DEVELOPMENT MANAGEMENT COMMITTEE 22nd May 2023

Case No: 22/02434/FUL

Proposal: Demolition of 2 outbuildings and erection of 8 Flats with integral parking.

Location: 26 - 28 The Broadway, St Ives PE27 5BN

DRAWING STATUS
Planning issue
DRAWING SCALE 1/100 @ A1
DATE OCT 2004
DRAWING NUMBER 1023.2 G F E D
REVISION

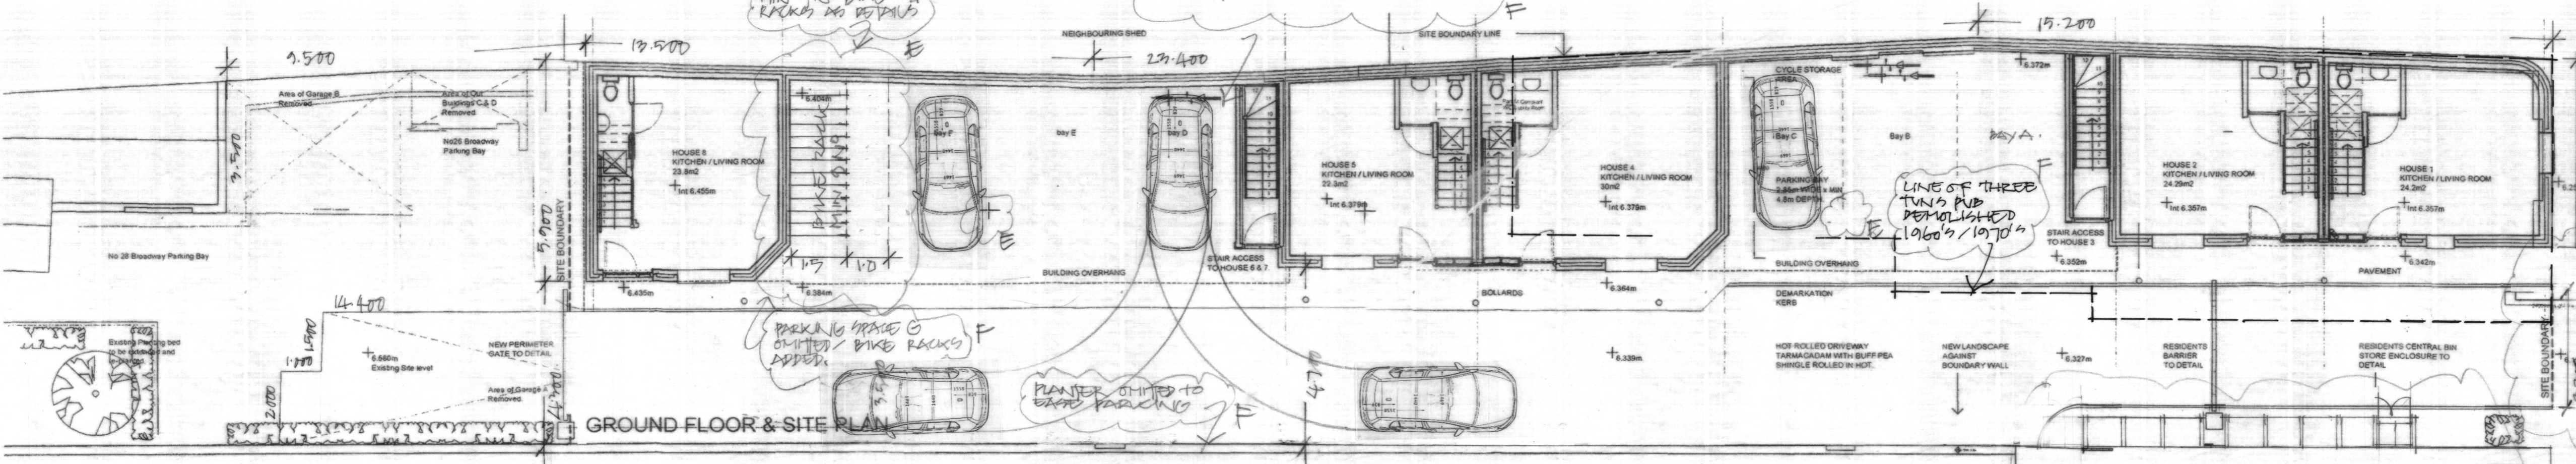
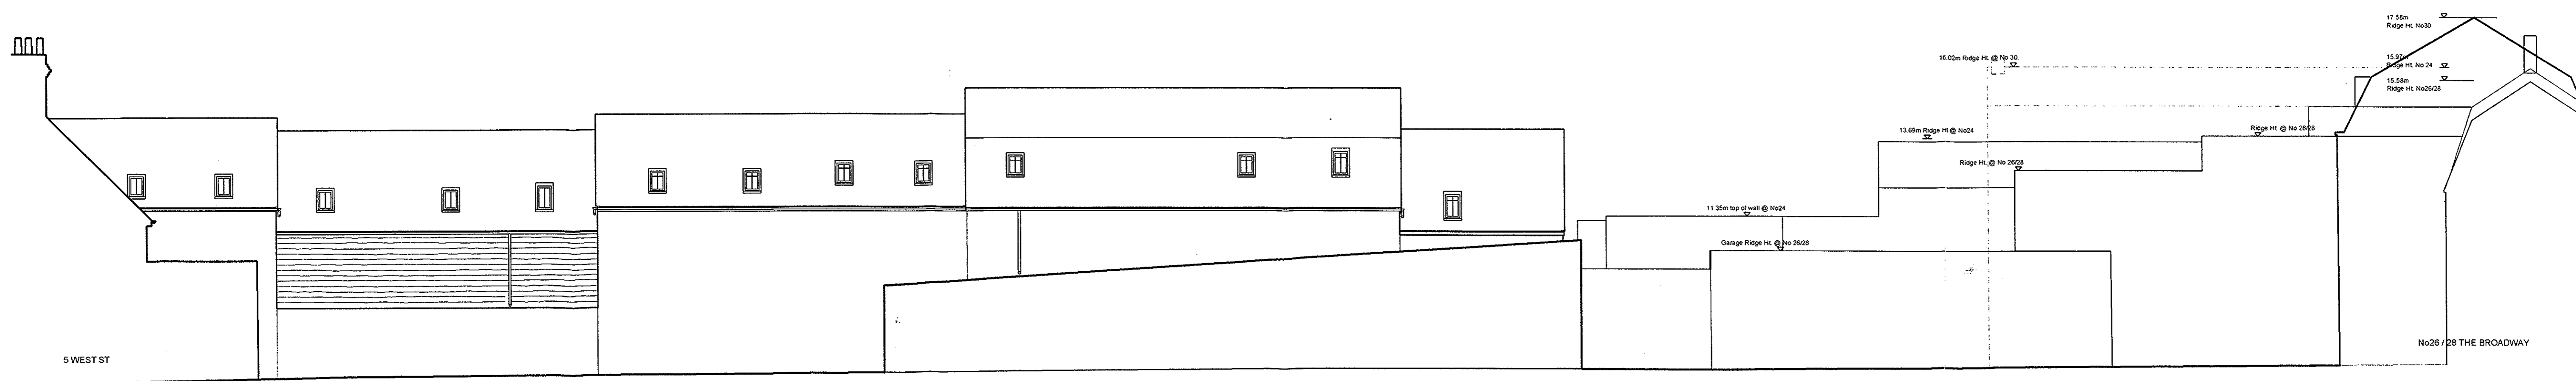
- 7.78 An amended plan was submitted (1023.2 Rev G) which includes vehicular tracking. Since the application was submitted the number of parking bays proposed has reduced from 7 to 6 to accommodate cycle storage and previously proposed columns and planters have been omitted to increase room for vehicles to manoeuvre.

- 7.81 The amended plans introduce an area of covered cycle parking within Bay G. This comprises a semi-vertical rack with a minimum of 9 stands - 1 per bedroom in accordance with Local Plan Policy LP17. Notwithstanding this, there is concern this rack system requires the user to lift the bike to an almost vertical position. Further, the rack design would also be unsuitable to accommodate a range of bikes including oversized bikes, children’s bikes and buggies and trailers.

- 7.83 Drawing 1023.2 Rev G continues to show cycle storage to the rear of parking bays B and D which would be unacceptable. It is considered that as submitted, the proposed cycle storage arrangement would not be suitably functional and secure to meet the requirements of future occupiers contrary to Policy LP17 of the Local Plan and page 96 of the Huntingdonshire Design Guide.
- 7.84 Overall, subject to conditions the proposed development is considered acceptable in terms of highway safety, car parking and vehicular manoeuvrability. However, the cycle storage requirements of the proposed development have not been met as the proposed cycle racks are considered unsuitable and unsecure. This aspect of the proposal is contrary to Policy LP17 and does not accord with the guidance for cycle storage for apartments set out on page 96 of the Huntingdonshire Design Guide.

DRAWING STATUS
 Planning issue
 DRAWING SCALE
 1/100 @ A1
 DRAWING NUMBER
 1023.3
 DATE
 OCT 2004
 REVISION
 B

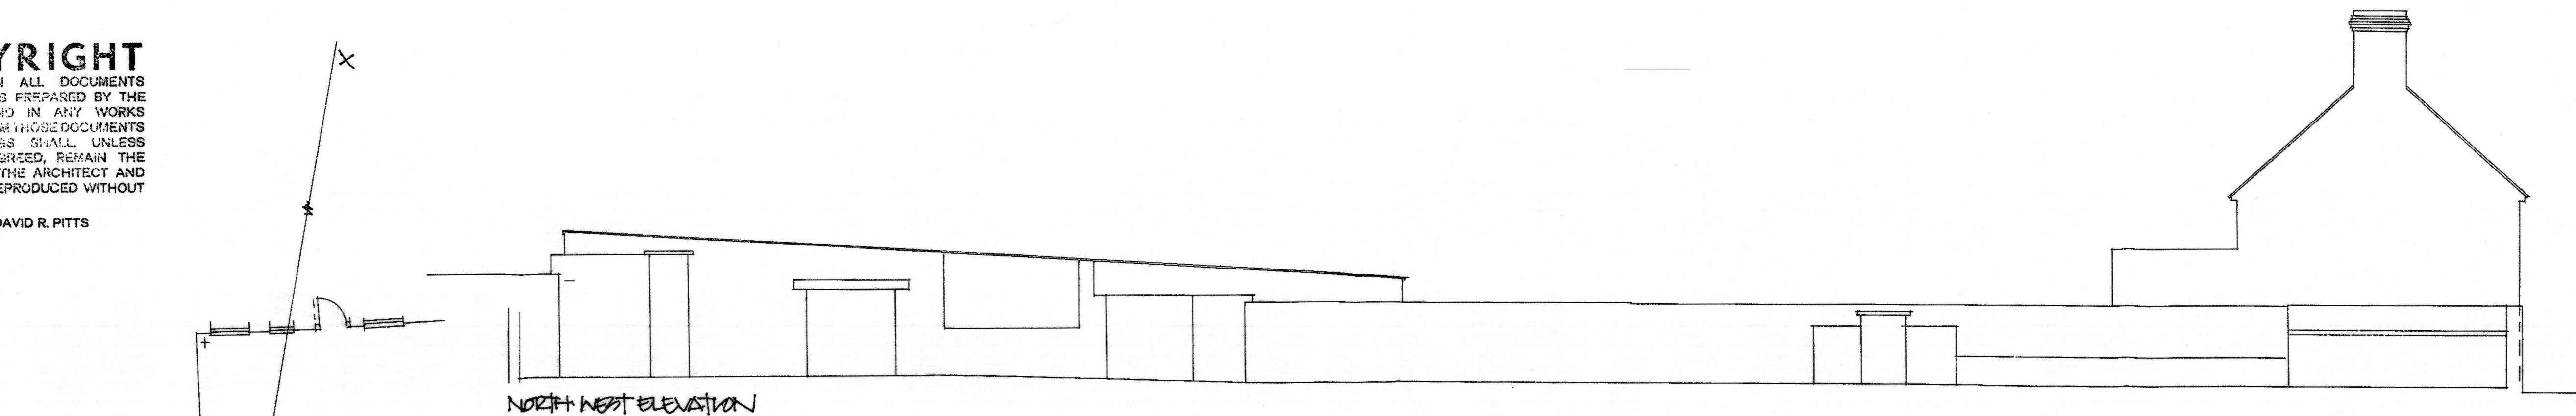
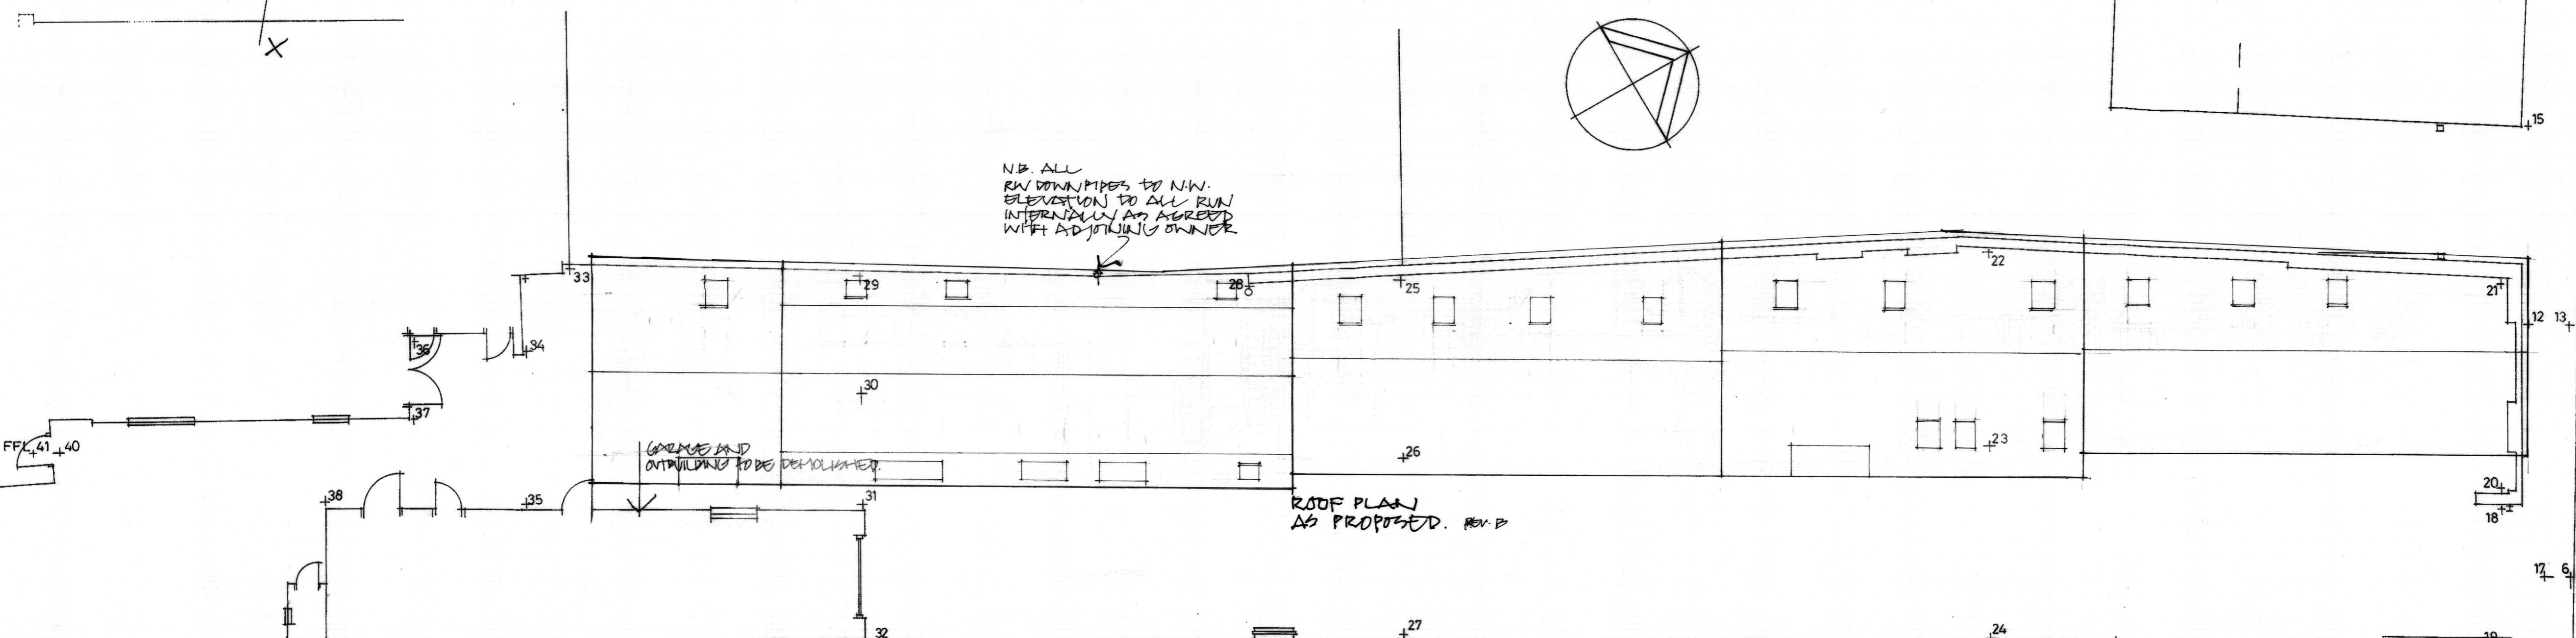
- 7.41 Unlike many of its neighbours 26 - 28 The Broadway is a relatively modestly scaled two-storey late 18th Century building under a mansard roof. The submitted Proposed Context Elevations (drawing number: 1023.3B) indicates that the ridge of the principal building is 15.58m with a rear wing stepping down to about 13.7m. The proposed terrace varies in height, but the tallest unit (6,7) is a mansard roof structure which would nearly match the height of the principal building and is taller than the rear wing. The proximity of this block (including unit 8) to the listed building and the lack of subordination in scale and massing would not preserve the setting of this building. There is no historic precedent for development in this area, and this massing is contrary to guidance given in the Character Statement.

DRAWING N° 1023.1

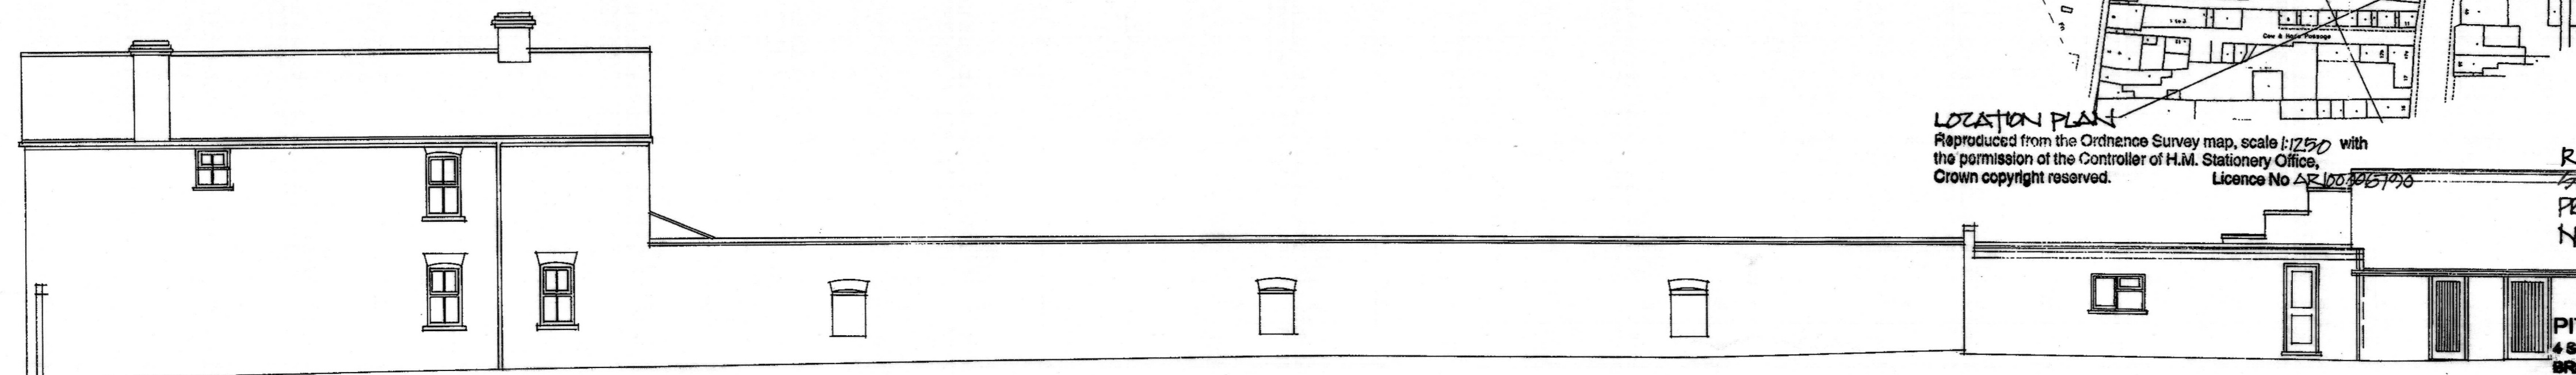
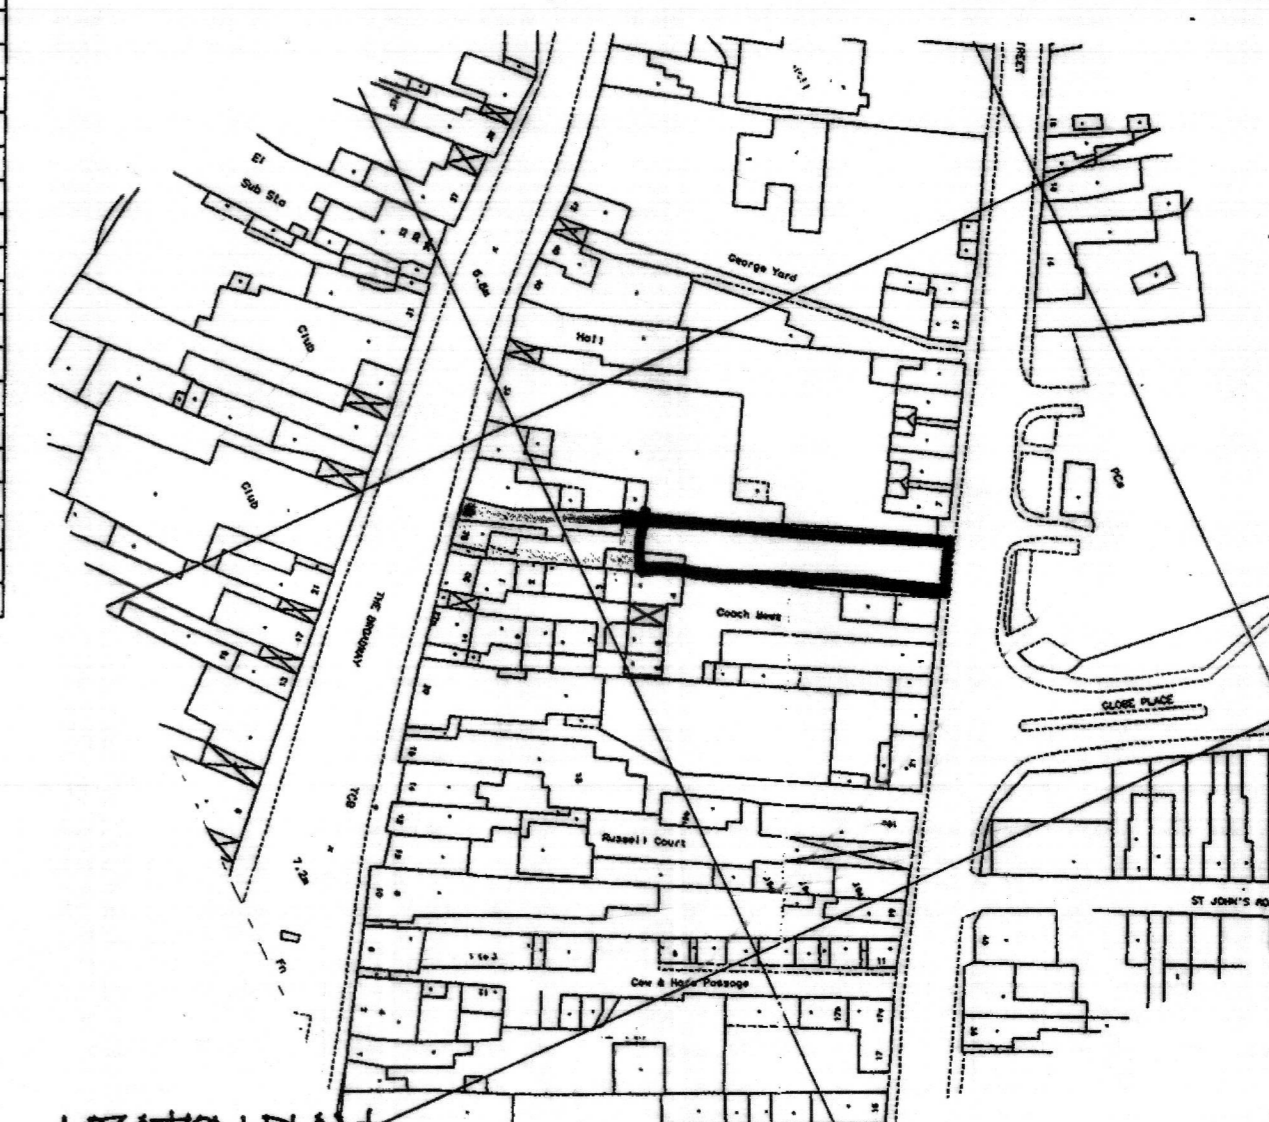
7.65 The planning agent has provided a plan (drawing number: 1023.1C) showing the outline of the former Three Tuns Public House which occupied the site and has stated that this proposal reflects the linear arrangement of the original public house demolished so they dispute claims to right of light relating to Coach Mews Cottage. The planning agent has also stated that the Coach Mews development does not comply with Building Regulation requirements then or now in relation to overlooking, obscured glass and fire proof glazing being within 1m of the boundary, so objection on this basis is unreasonable.
